SERVICE INFORMATION BULLETIN

Subject:
THE MATERIAL OF THE ROCKER ARM SUPPORT BOLT AND CAMSHAFT BEARING CAP BOLT WAS CHANGED ON THE J05D ENGINE

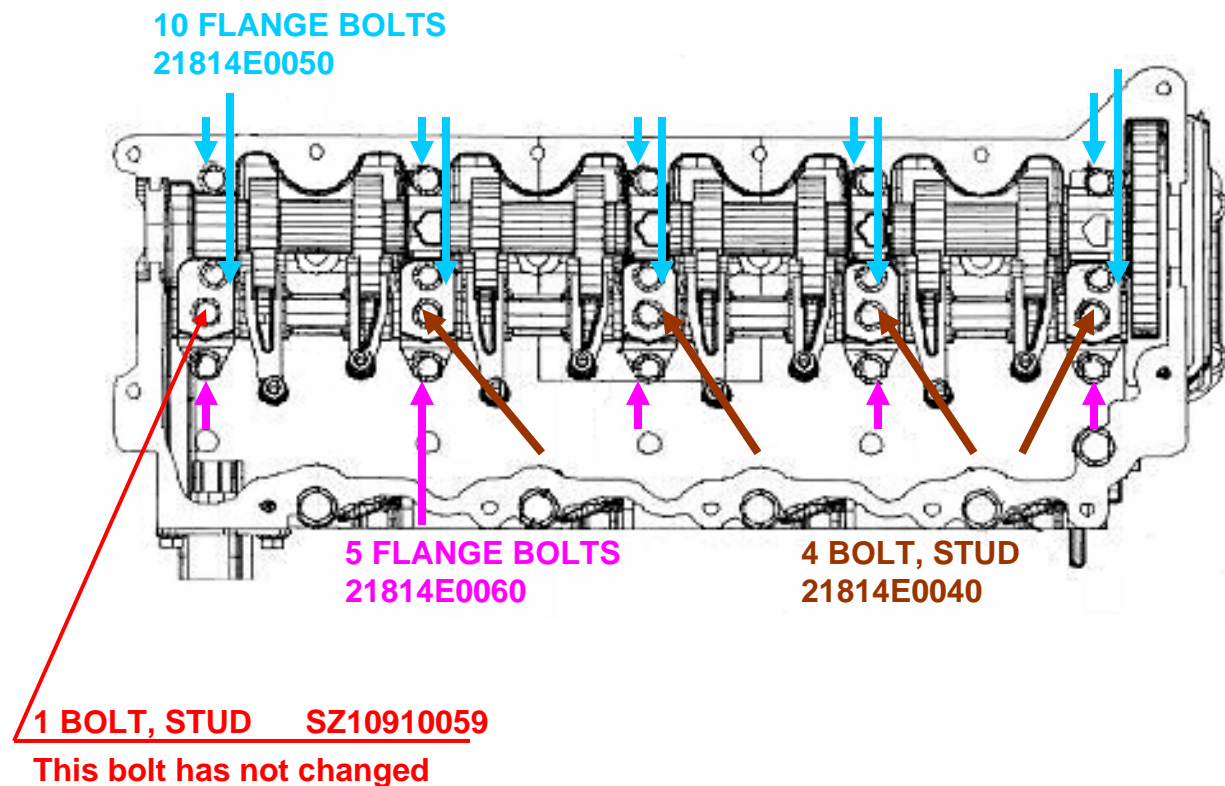
The document is to inform the dealers about the change in material and tightening torque of the rocker arm support bolts and camshaft bearing cap bolts.

The material and the tightening torque of the rocker arm support bolts and the camshaft bearing cap bolts will be changed as the illustration shows below.

DESCRIPTION	CURRENT	NEW
DIAMETER X PITCH	M8 X 1.25	M8 X 1.25
TIGHTNING TORQUE	21 lbf.ft. (28 Nm)	27 lbf.ft. (36 Nm)
	 7T	 9T
BOLT, FLANGE	SH55210850	21814E0050
BOLT, FLANGE	SH55210885	21814E0060
BOLT, STUD	SZ10908073	21814E0040

The *NEW* parts are interchangeable with current engines, but the *CURRENT* parts are not interchangeable with new engines.
